# MEMORANDUM

SUBJECT: Site Plan Approval – 1068 Arsenal Street

DATE: July 31, 2025

**Request:** Site Plan Approval to construct a 510 square-foot (SF), drive-through coffee shop, a 388 SF storage building and associated site improvements at **1068 Arsenal Street**, Parcel Number 8-47-106.200

C0.2  
AREA PLAN

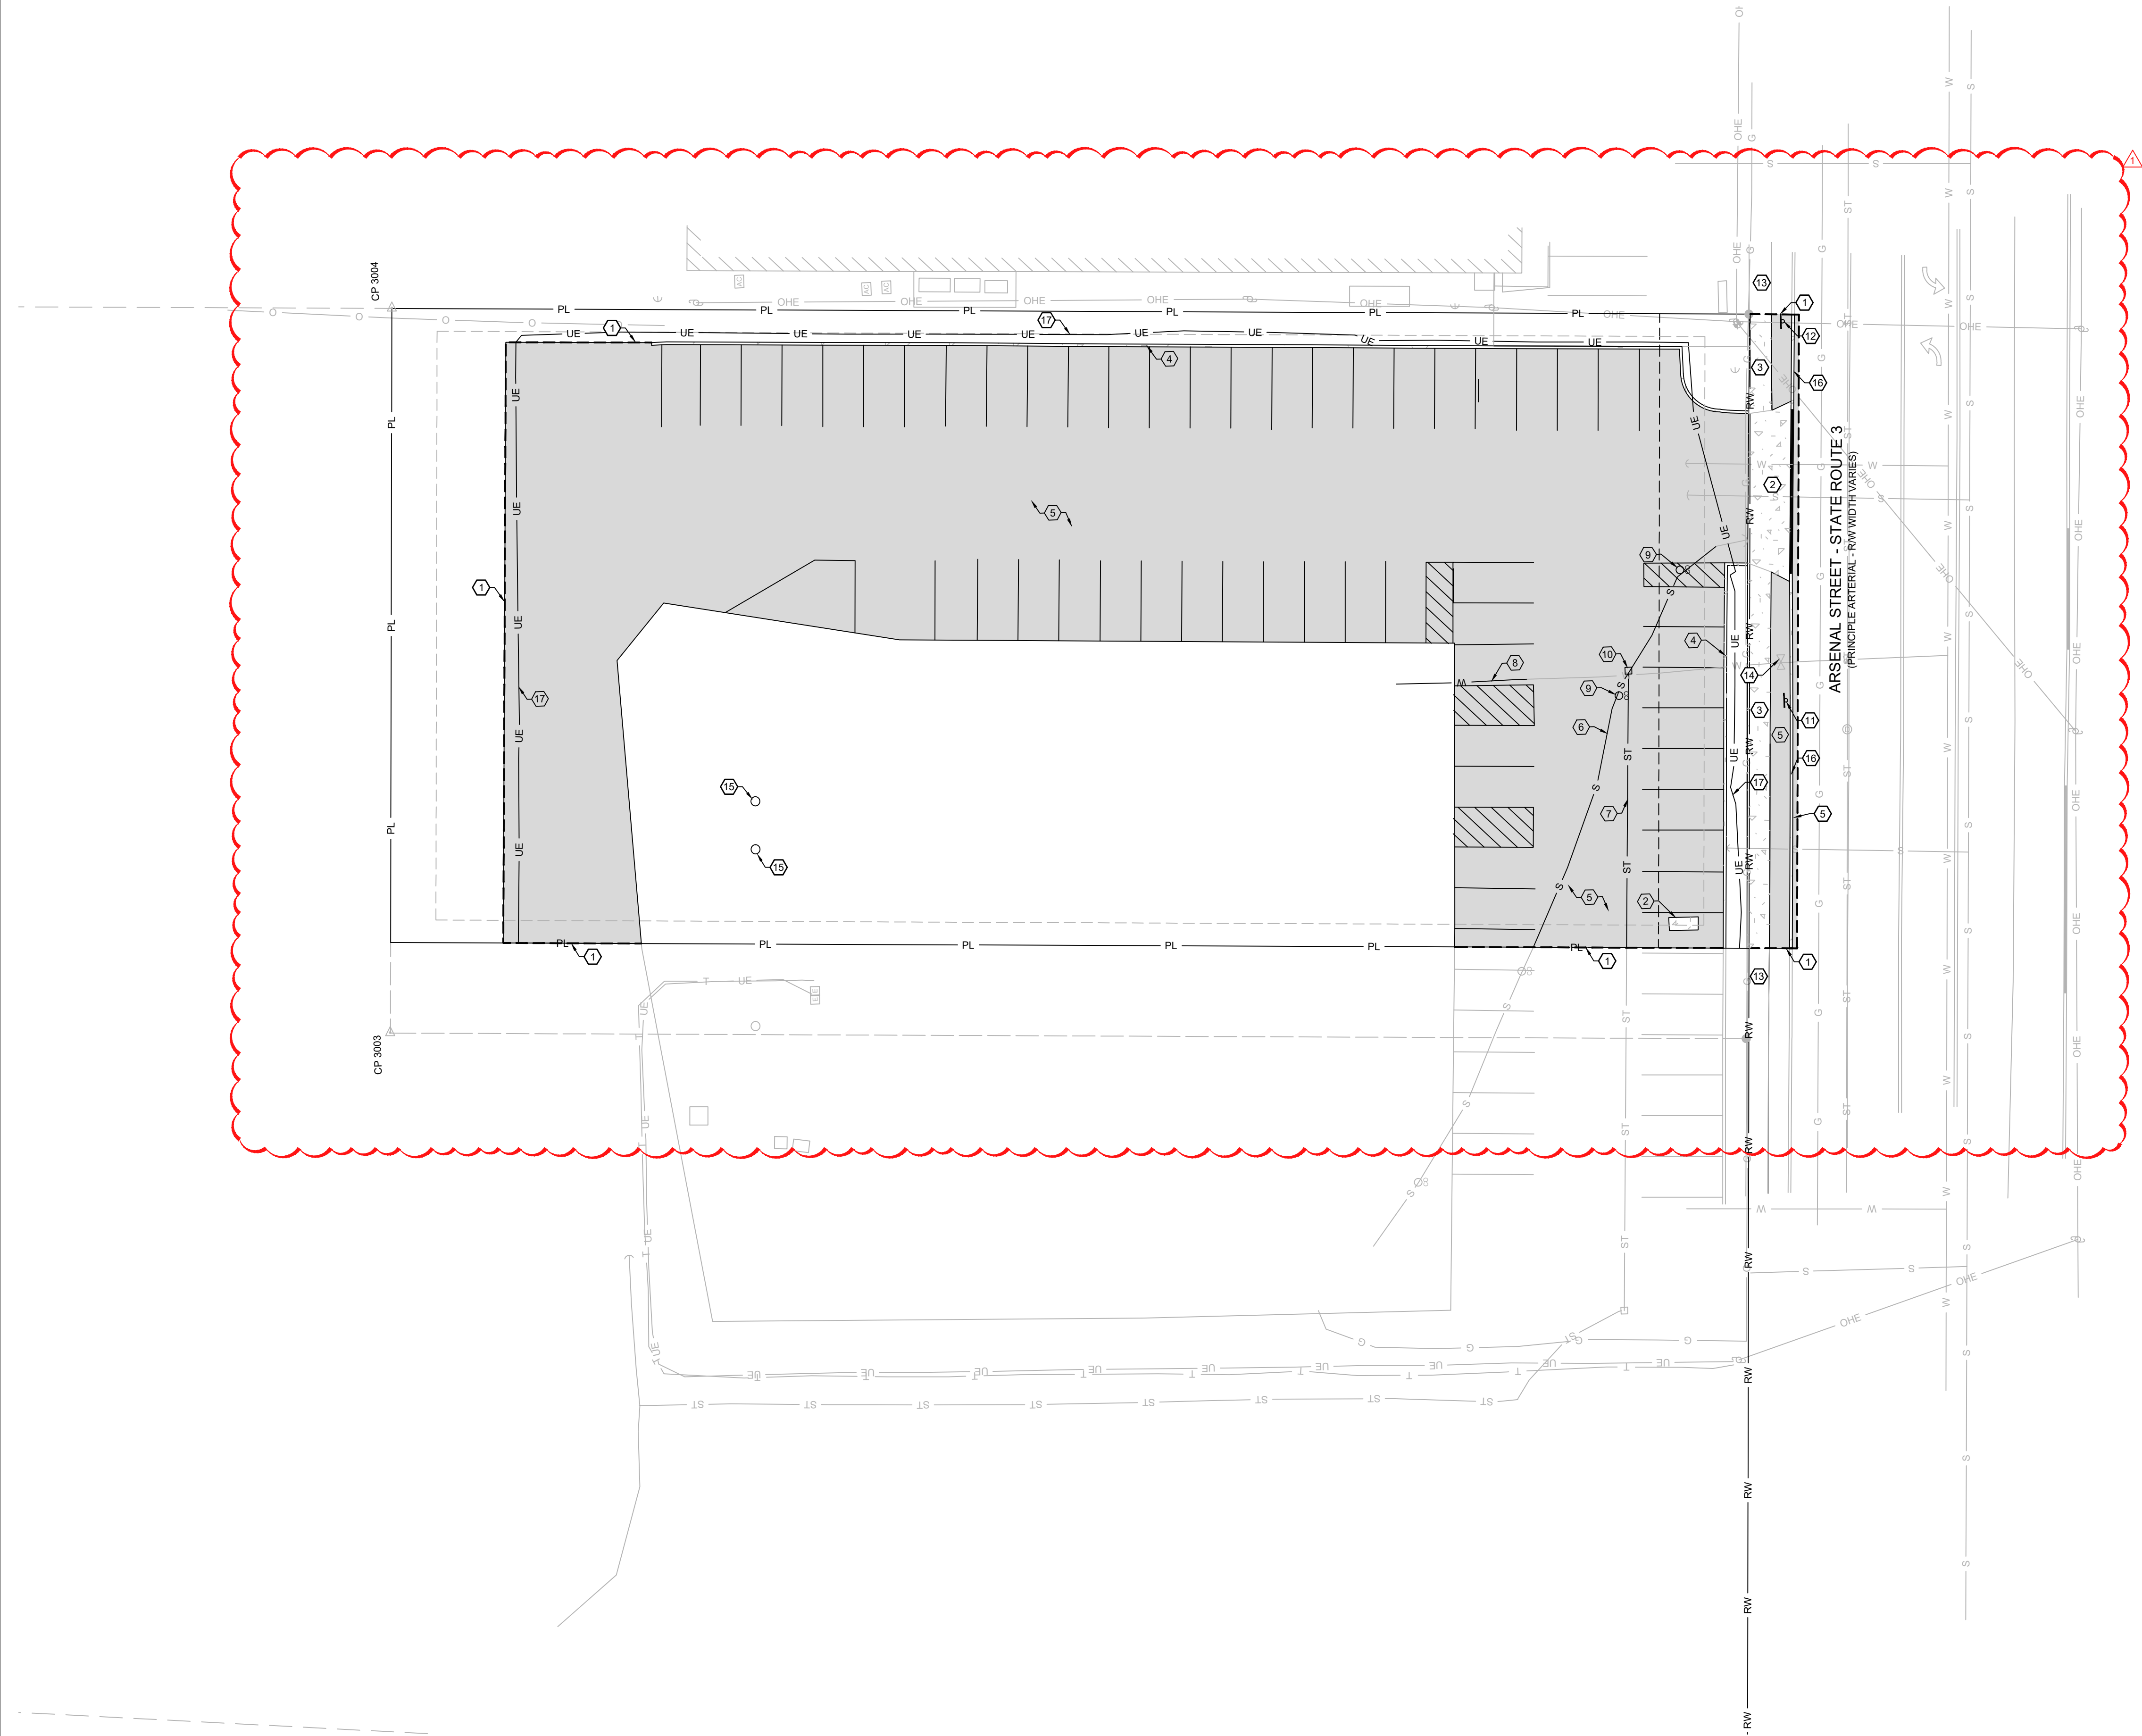
1. The applicant shall either achieve conformity with the 70 percent lot area coverage requirement or obtain an Area Variance from the Zoning Board of Appeals. *The applicant has submitted a Subdivision Approval application, which appears as a separate item on the Planning Commission's August 5, 2025 meeting agenda. However, any motion to approve that Subdivision will be conditioned on submitting a Subdivision Final Plat Drawing and on filing deeds for subsequent assemblages with the County Clerk. Therefore, this summary item must remain but should be reworded as the following: "The applicant shall fulfill all conditions of the Subdivision Approval granted by the City of Watertown Planning Commission at its August 5, 2025 meeting."*

Response: An Area Summary has been added, see revised 0.2 Area Plan.
2. *The applicant shall clarify whether they intend to seek a future Subdivision Approval for the westernmost 20 feet of the subject parcel.*

C2.1  
SITE PLAN

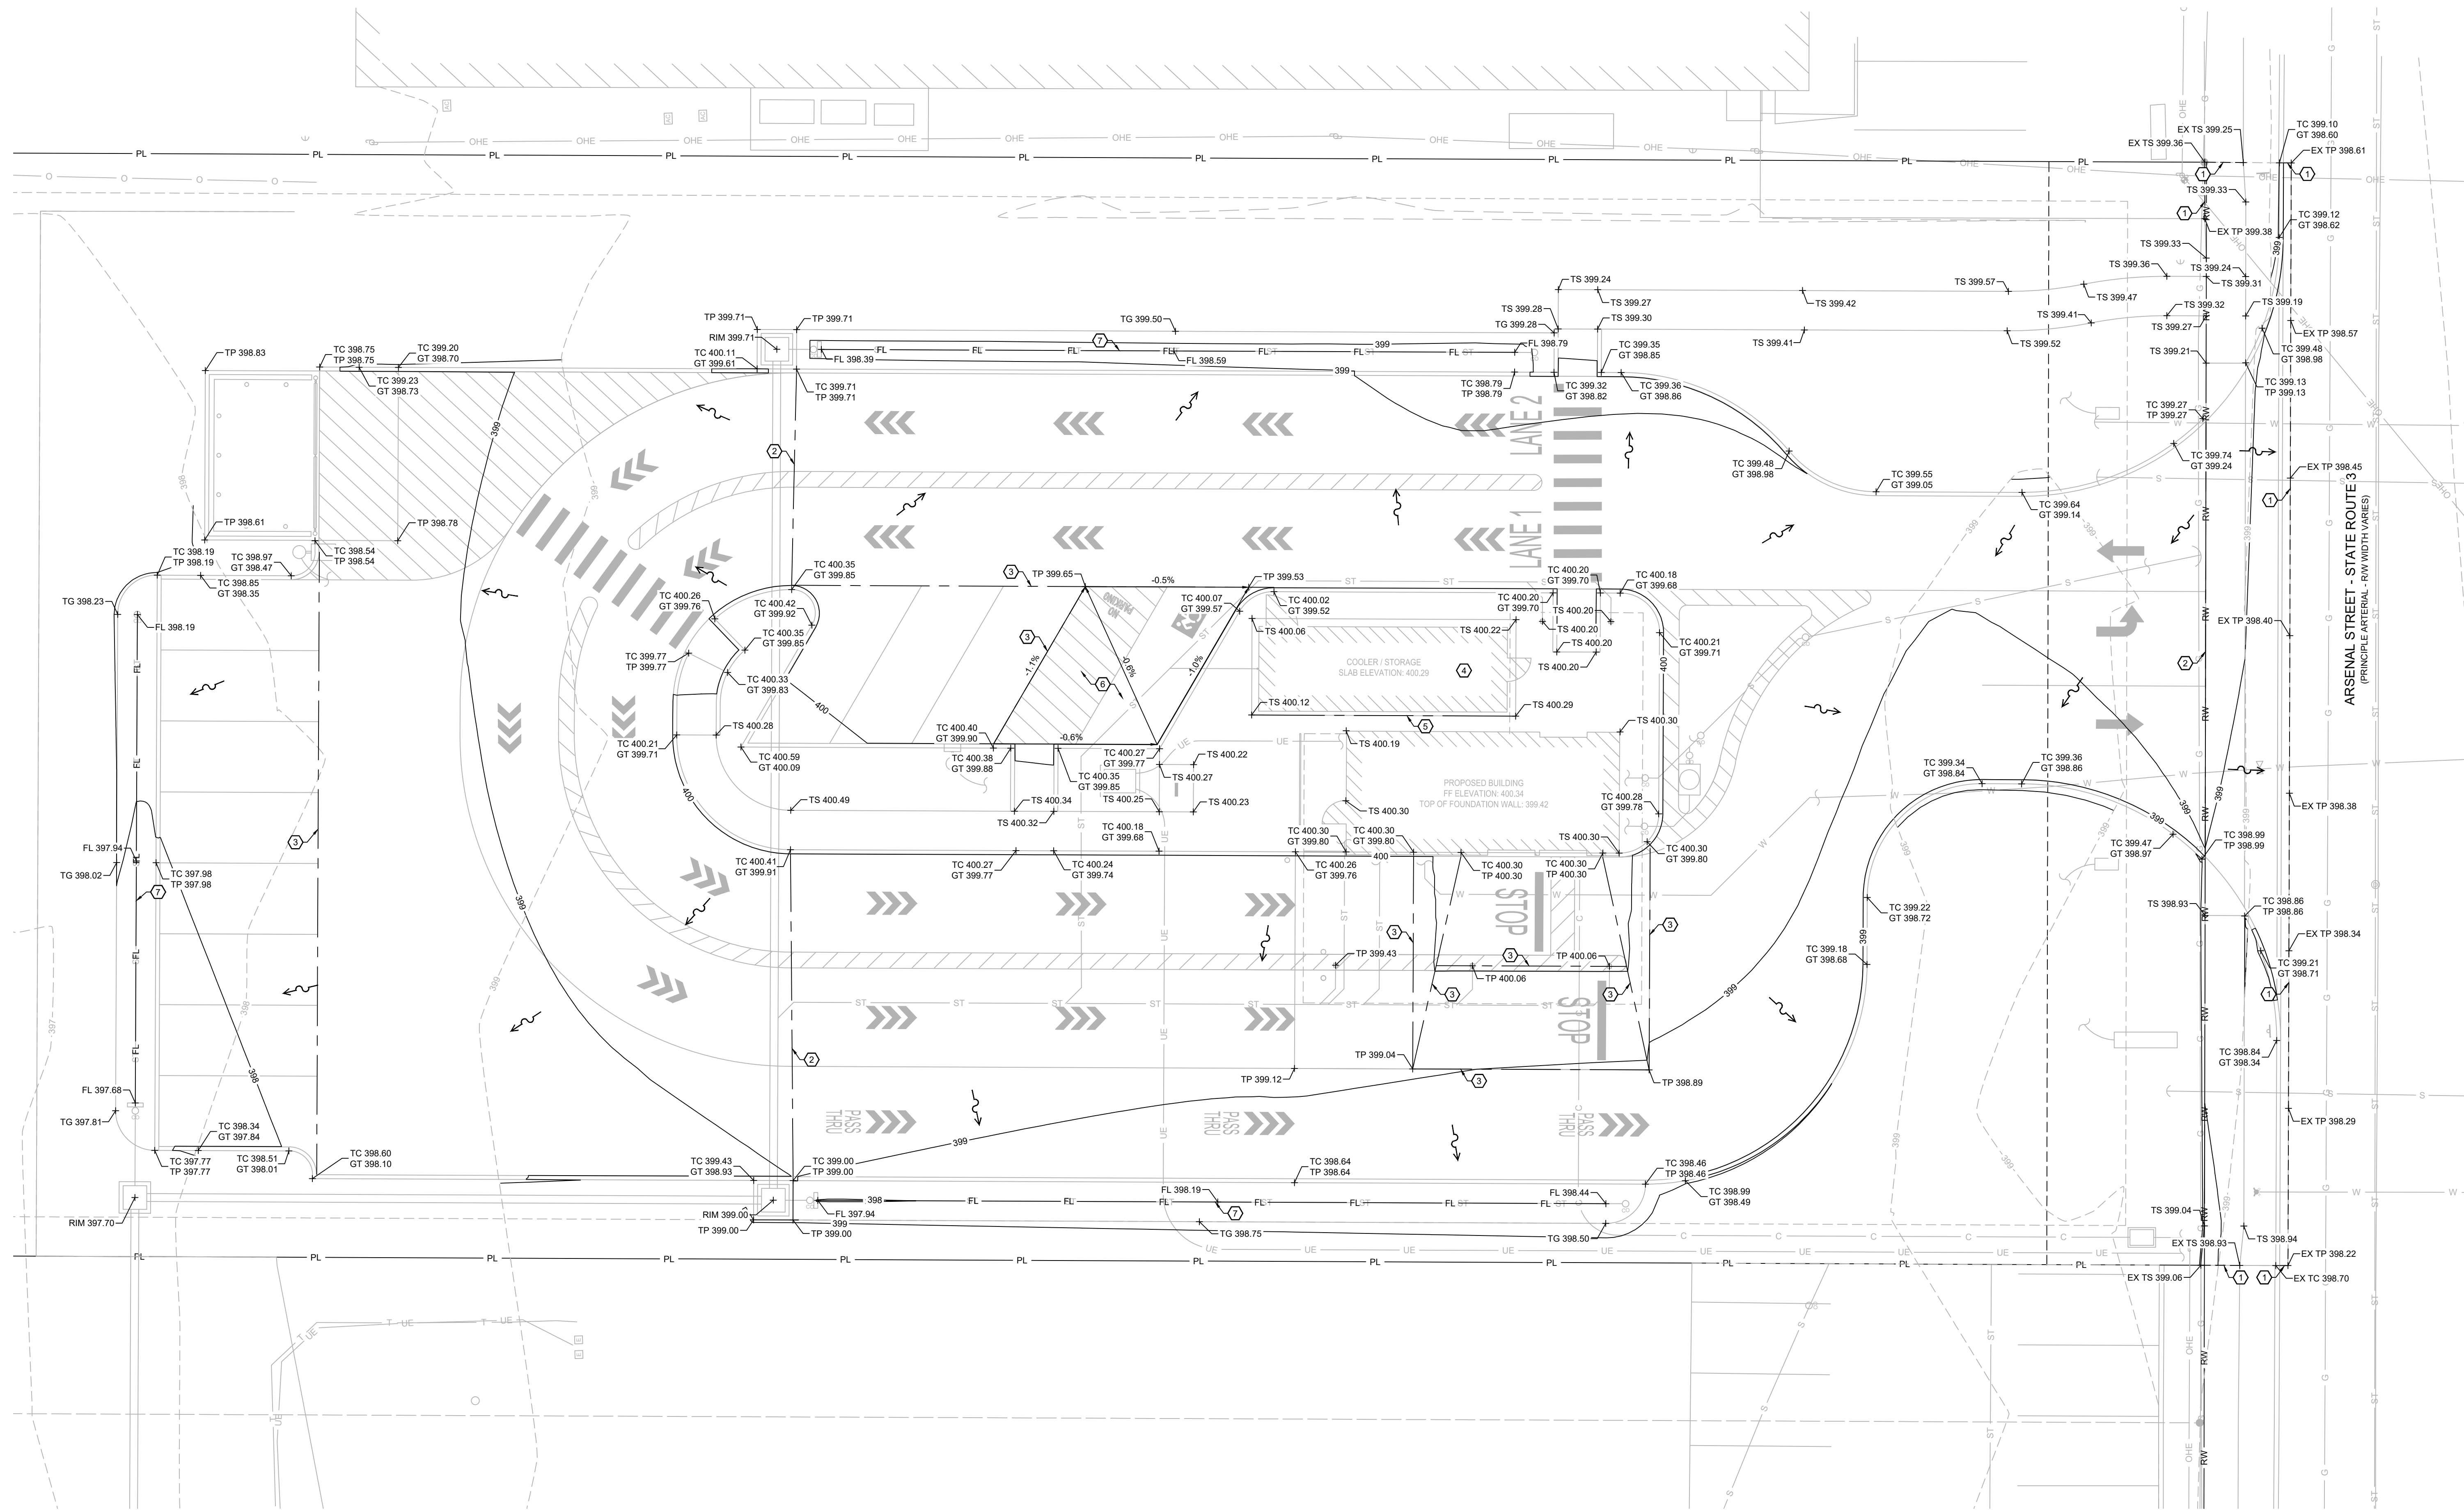
- Sheet C2.1 – Site Plan
  - *Note 15 calls for new signs and references sheet C6.1, which calls for coordination with NYSDOT for final location(s). Provide a detail consistent with a NYSDOT break-a-way sign post base detail.*
- Sheet C1.1 – Demolition Plan
  - *Note 11 calls for the removal and relocation of the "NO STANDING ANYTIME" sign. Where is the sign proposed to be located?*
  - *Note 9 calls for the removal of the sanitary clean out.*

The C2.1 Drawing (Site Plan) contains a note that reads, “*Calculations provided for impervious surface limits are the limits of disturbance.*” The applicant therefore calculated the post-project lot coverage only for the 40,072 SF being developed. However, the 70 percent lot area coverage maximum applies to the entire parcel, which is 48,000 SF, yielding a maximum lot area coverage of 33,600 SF. This means that the unimproved areas around the north and west edges of the site may not remain as hardscape, as at least 14,400 SF of the parcel must be permeable surface.
